Independent Advisory Panel to IDB Invest

IAP Report N°6, July 2021

Ituango Hydropower Project

Colombia

Figure 6: Reservoir lowering times (Integral)

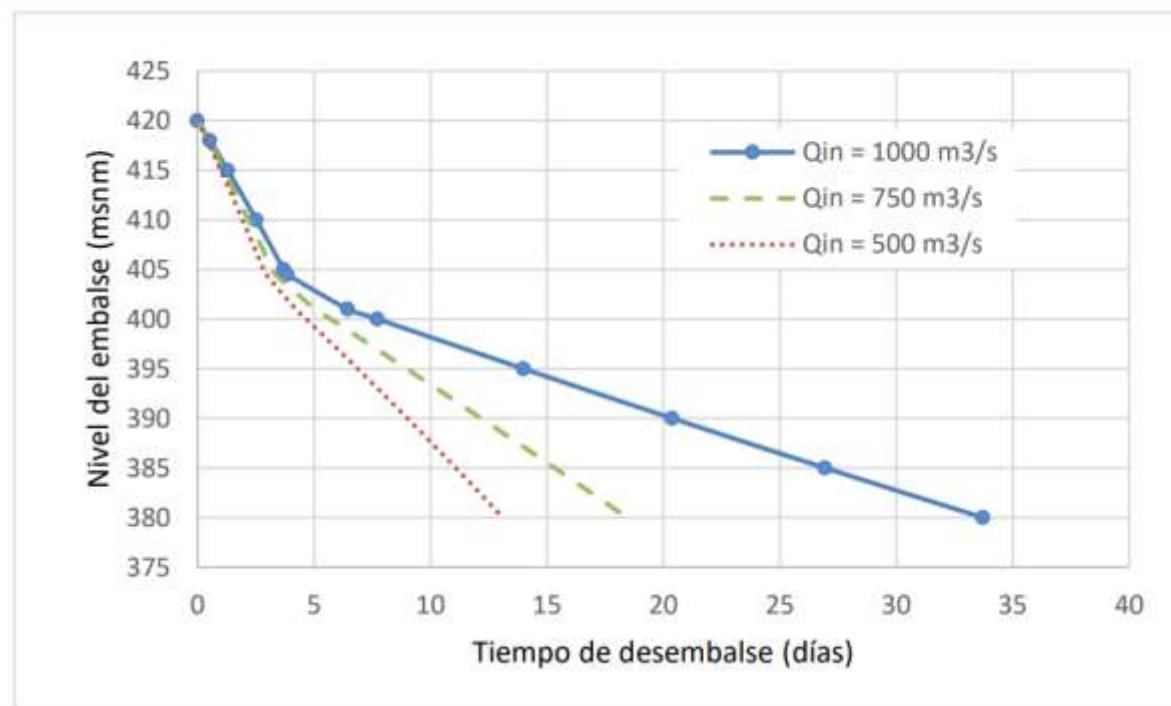
It must be pointed out that the current plan envisages 4 units entering in operation by September 2023, and all the 8 units by February 2025. The data shown in figure 6 will therefore be valid in the long term. Until the year 2025, lowering times will be about twice

those shown and effective reservoir control will hardly be possible for river flows exceeding, say, 500 m³/s.

Integral informed that the possibility to lower the reservoir below 390 m.asl will be contemplated in the Emergency Preparedness Plan (EPP) because there are no doubts on the trade-offs between causing temporary damage to the equipment, and failure of the dam. Integral also informed that the plant will store four spare runners that can be mounted from below, making repairs of possible damages easy to perform. This is a very appropriate management measure to mitigate outage risks.

Ituango's EPP should incorporate two elements:

- a short term (4 units in operation) discharge response system, and
- the extent of the potential damages in case of protracted operation of the units below minimum OL (390).

Figure 7: Rio Cauca's longitudinal profile

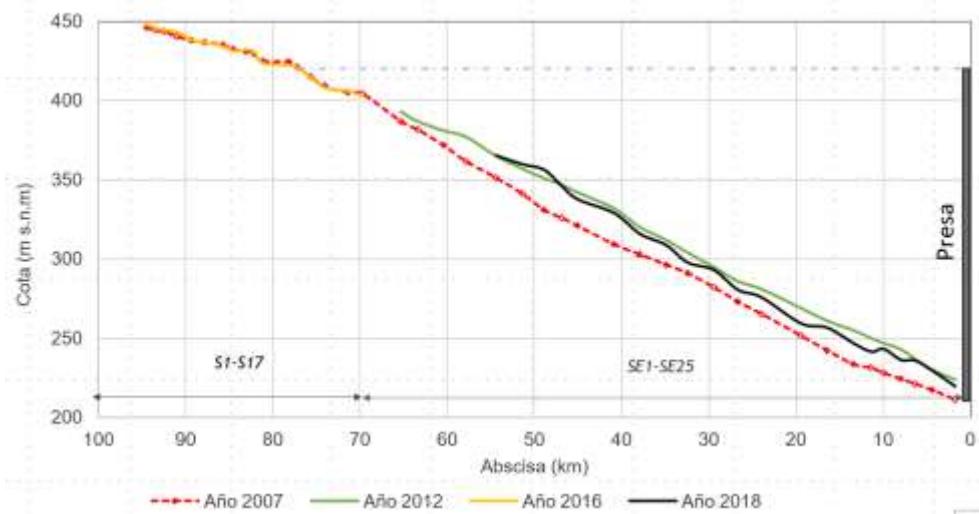
- The apparent incongruence between LiDAR (year 2012) and topography (2016), both executed before reservoir filling, is explained by the fact that LiDAR does not fully penetrate wet areas.
- The same explanation applies to the LiDAR survey profile being above the 2018 bathymetric survey.
- Besides, those differences apply only to elevation near to the river bed and, as such, any discrepancy would have a negligible contribution to the reservoir volume (see figure 8).

In this initial stage of the Project, the key decision to make is about the baseline reservoir's geometry to associate to future bathymetric surveys. Based on the above observation, the IAP believes that the cartography of year 2007, validated by the 2016 topographic surveys, represents a suitable baseline.

Figure 10: Extensometer readings

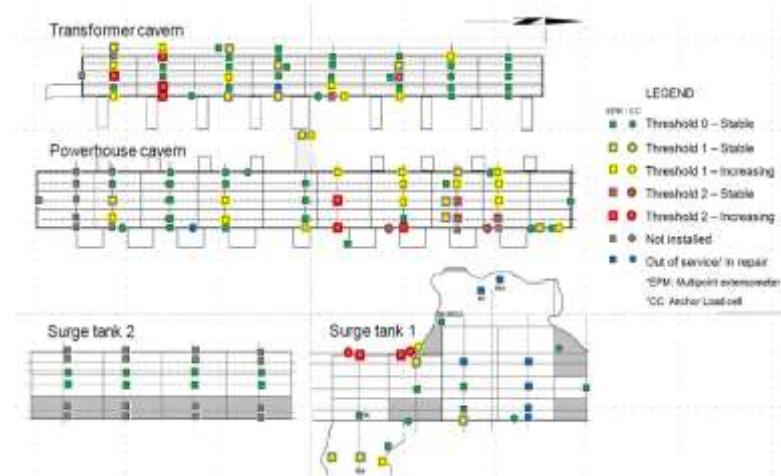
A few extensometers do not show achievement of full equilibrium (see fig. 10). Detailed review of future trends might suggest the need of additional rock mass reinforcement.

Measurement interpretation uses three reference “Thresholds: 0, 1, and 2”; the IAP is not privy to such thresholds and would like to know about them.

Figure 11: Conceptual model of the Disturbed Rock Mass

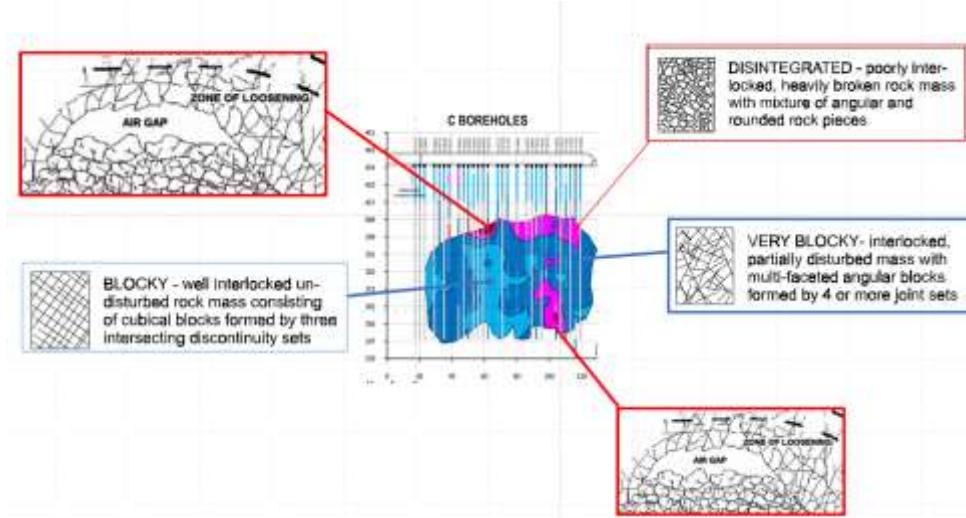
Findings of the investigations carried out to date are in line with the geo mechanical model postulated in the IAP’s 5th Report (see fig. 11). Voids seem to be significant although part of

them can be explained by a low total core recovery, not necessarily associated with voids. Also, a major part of the surrounding is just jointed rock mass. This is clear comparing the recorded grout consumptions with those anticipated. A good number of inclined check holes will be necessary to confirm that strengthening and filling works are acceptable.

It should be expected that, as excavation works reveal the actual rock mass conditions, some areas showing instability or excessive damage will require special reinforcement and/or concrete backfill. The characteristics of such areas will have to be considered in the design of the shafts' permanent lining.

Lining design will depend on the stiffness of the same, relative to that of the rock mass. If the rock mass modulus of deformation is not negligible in comparison to that of the concrete, a fair amount of the internal pressure can be transferred to the rock mass. The IAP believes that the modulus of the less disturbed or even fairly jointed gneissic rock mass is in the order of 10 GPa, allowing part of the internal pressure to be transferred to the rock. This assumes that the zones with large voids are adequately treated/ backfilled.

Figure 13: Slope stability analysis – Profile A-A

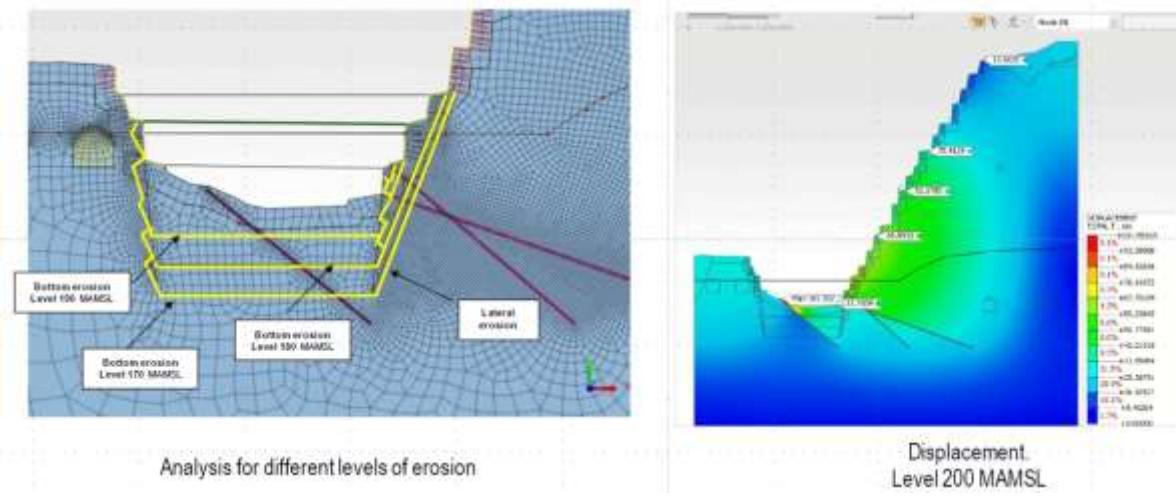
Slope stability analyses have been conducted with a finite element code using a strength reduction factor (SRF). The meshing seems adequate; however, the full dimensions of the model are not obvious. If that shown in fig. 13 represents the total FEM model, it is possible that the boundaries may be affecting the results.

High pore pressures, that could denote a more unfavourable condition, do not seem to exist. The IAP assumes that seismic conditions were also checked and would like to be briefed about them in the next visit.

It would also be useful to show the maximum shear strain contours, at the critical SRF, that are indicative of the critical failure surface.

Figure 14: Protection measures to slope above the diversion tunnels

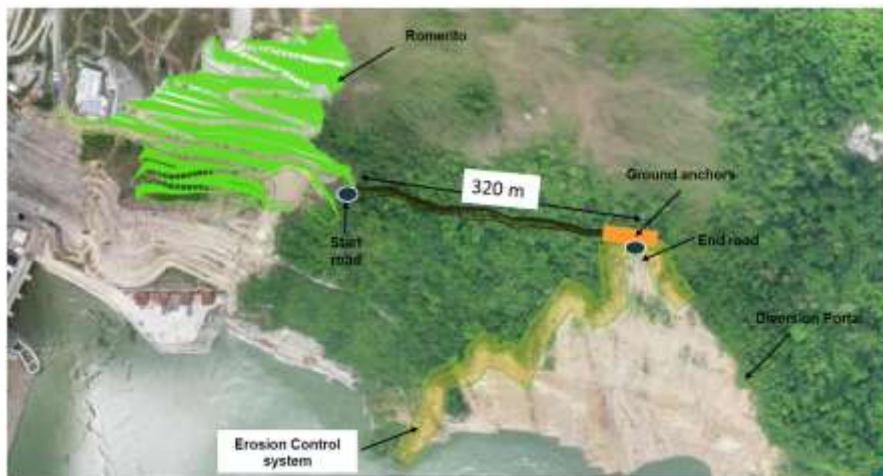
IAP agree with the proposed measures, designed to prevent the uphill extension of the instability phenomena, and further erosion from surface runoff (figure 14).

IAP reiterate the need to closely monitor the slope with ground monitoring, in addition to remote techniques.

Figure 39: Unit 1 time to completion – electromechanical and civil works

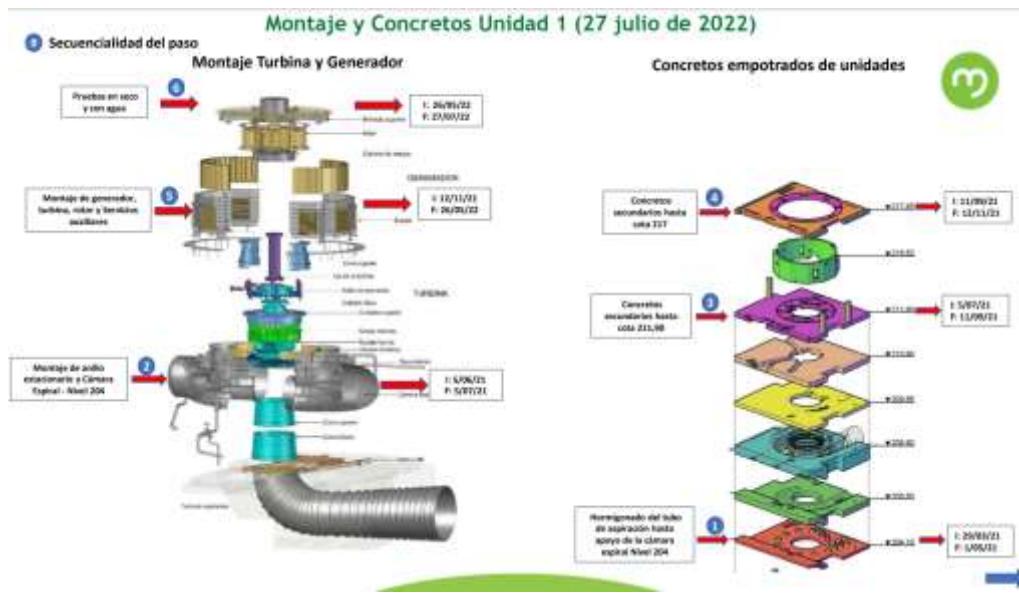
Phase 1 should have been completed on May 1st but, due to assembling of Spiral Case, Phase 2 scheduled to be completed on July 5th 2021 has accumulated some delay.

Figure 48: Time Line on 30 June 2021 Permanent Sealing of TD2 and GAD

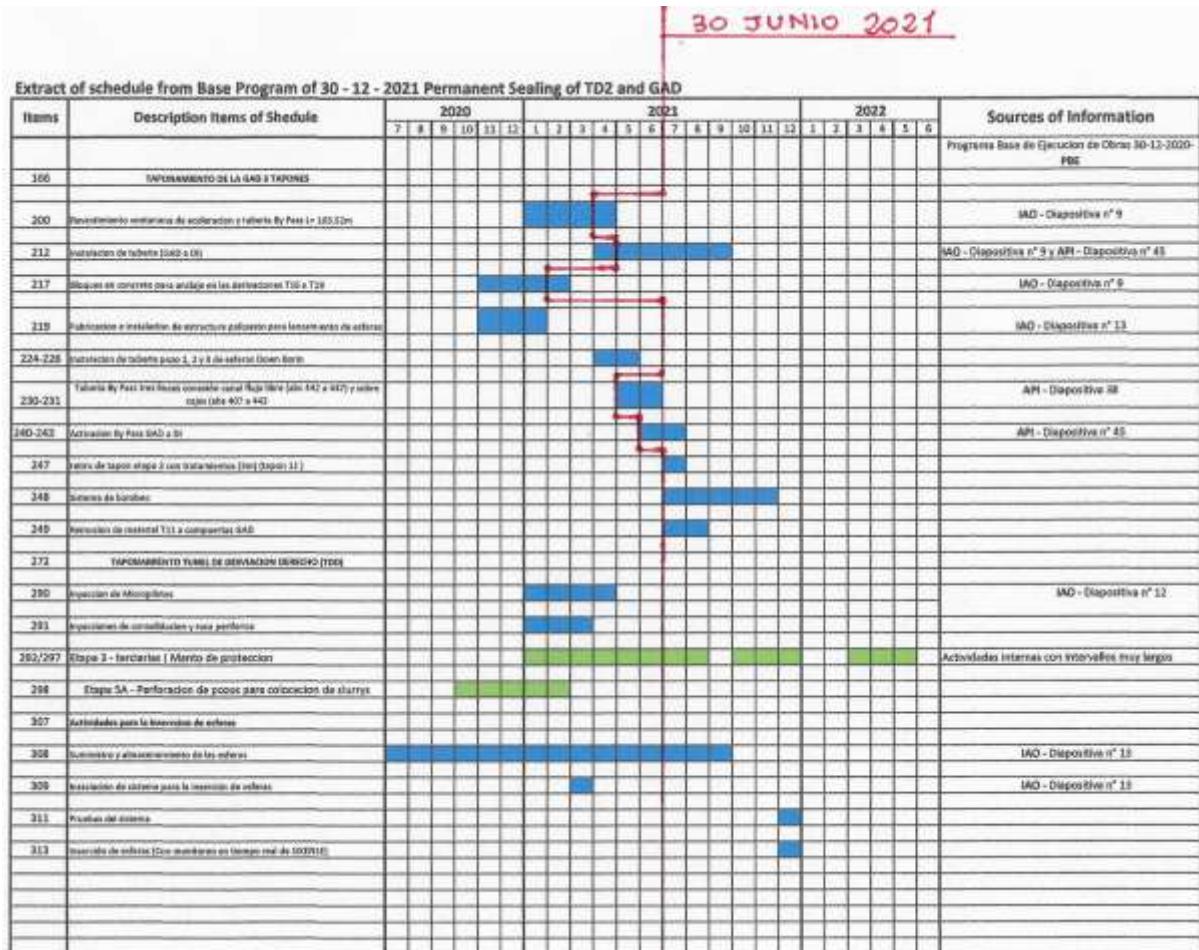
Also in this case, the work items have been derived from EPM Chronogram (*Programa de Ejecución de Obras_PBE*) on 31st December 2020, and the corresponding codes retained (first column). In addition to the PBE, other two sources of information have been used:
